CITY OF ALBUQUERQUE

RE: **Lot 8 Block 11 Volcano Cliffs Unit 18 SAD 228**
6520 Petirrojo NW
Grading and Drainage Plan
Engineers Stamp Date 9/11/19 (D10D003H26)
Pad Certification Date 9/5/19

DRAINAGE AND TRANSPORTATION INFORMATION SHEET (REV 6/2018)

Project Title: 6520 PETIRROJO **Building Permit #:** _____ **Hydrology File #:** _____
DRB#: _____ **EPC#:** _____ **Work Order#:** _____
Legal Description: lots 8 block 11 volcano cliffs unit 18
City Address: 6520 PETIRROJO

ENGINEER'S SEAL 8/11/19 DAVID SOULE P.E. #14522	LOT 8 BLK 11, U 18 VOLCANO CLIFFS 6520 PETIRROJO ROAD NW	DRAWN BY DEM
	GRADING AND DRAINAGE PLAN	DATE 8-12-19
	 1608 CENTRAL AVENUE SE SUITE 201 ALBUQUERQUE, NM 87106 (505) 972-0899	LOT 8 BLOCK 11 VOLCANO CLIFFS.DWG SHEET # C1 JOB #

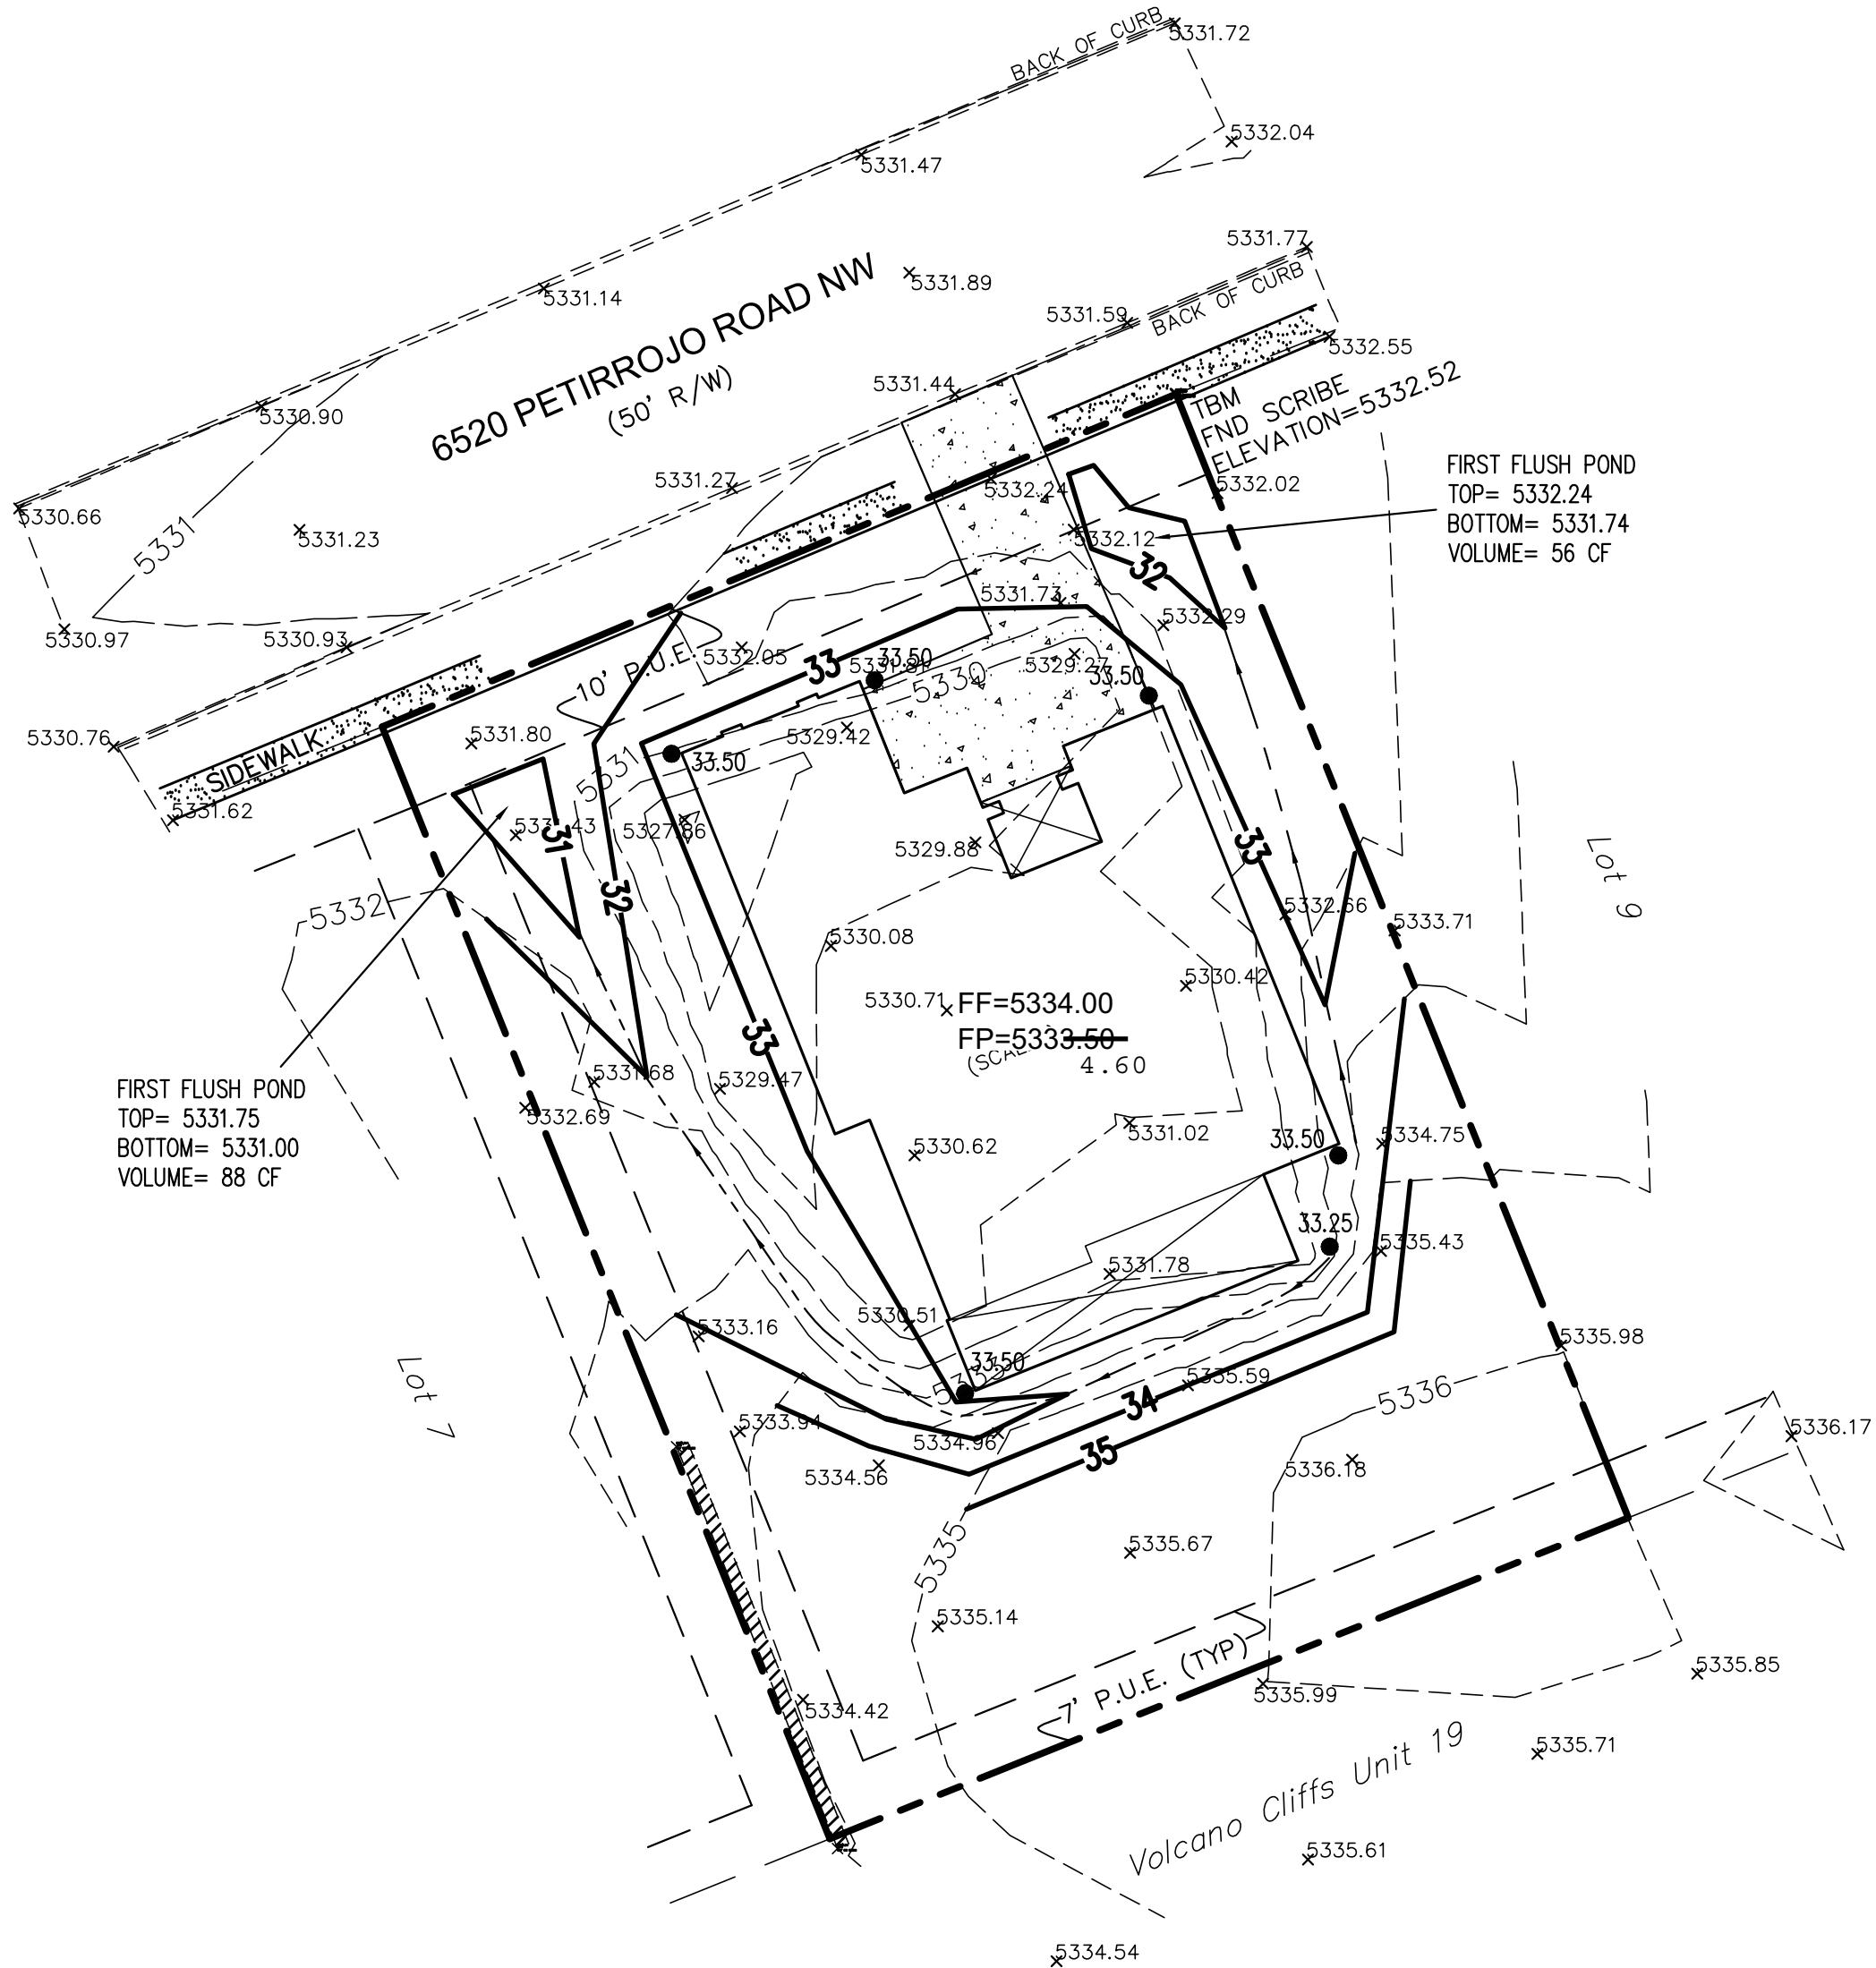
Based upon the information provided in your submittal received 9/5/19, this plan is approved for Building Permit.

Reiterate to the Owner/Contractor that a separate permit for a garden/retaining wall must be obtained, with the approved G&D plan dated 9/11/19 and Pad Certification Date 9/5/19.

Prior to Certificate of Occupancy release, Engineer Certification per the DPM checklist of this plan will be required.
